Safety Alert

End Facing Attachment

THERE WERE TWO DESIGN FLAWS DISCOVERED ON ACP SPREAD 8 OF THE SWIVEL ATTACHMENT FOR THE ENDFACER WHICH ATTACHES TO THE EXCAVATOR STICK AT THE END PIN HOLE.

SWIVEL STOPPED BY LOCKNUT

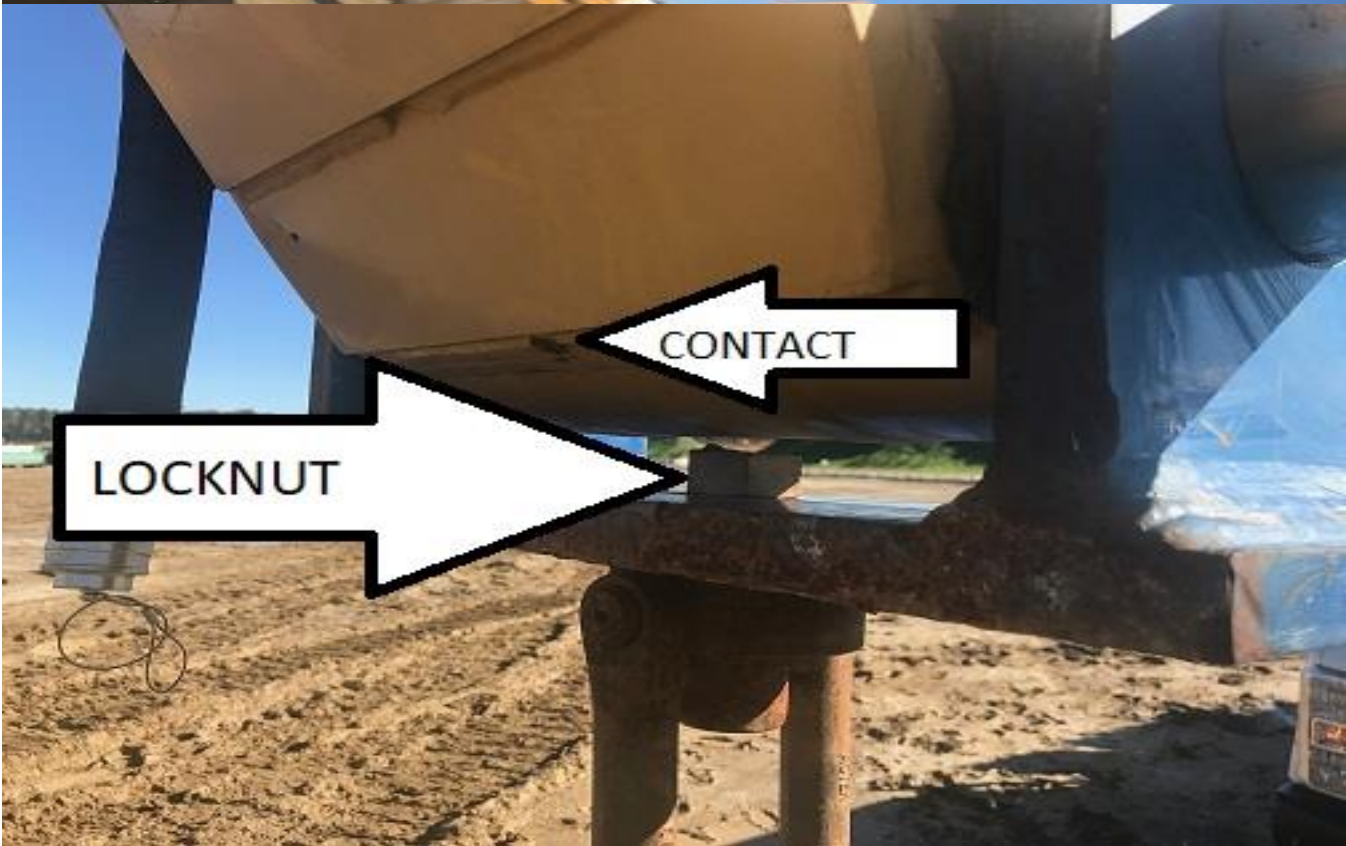
THERE IS NOT ENOUGH CLEARANCE FROM THE HOLE CENTER TO THE TOP OF THE PLATE THAT THE RIGGING ATTACHES. IN ADDITION THIS LACK OF CLEARANCE HAS CAUSED A LOCK NUT TO BE USED IN LIEU OF THE CORRECT MACHINE NUT. THE THINNER LOCKING NUT STILL CONTACTED CATERPILLAR EXCAVATORS DUE TO THE FACT THE DIMENSION FOR THE END OF THE STICK TO THE CENTER OF THE PIN HOLE IS GREATER THEN ON OTHER EXCAVATORS. THIS "BOTTOMING OUT" ON THE LOCK NUT DAMAGES THE NUT CAUSING POTENTIAL FAILURE AND DROPPING OF THE END FACER.

CONTACT

LOCKNUT

A THREE INCH RISER WAS INSTALLED ON TOP OF THE ORIGINAL SWIVEL PLATE TO ALLOW FOR SUFFICIENT CLEARANCE AND A PROPER MACHINE NUT. THERE IS NO POSSIBLE POTENTIAL FROM CONTACT OF THE BOLT OR NUT USING THIS DESIGN. AS AN ADDED PRECAUTION THE NUT IS TACK WELDED.

THREE INCH RISER ADDED TO TOP PLATE OF SWIVEL WITH CLEARANCE HOLE TO ACCESS CORRECT NUT WITH A SOCKET.

VIEW OF THROUGH HOLE TO ALLOW ACCESS TO CORRECT NUT WITH SOCKET.
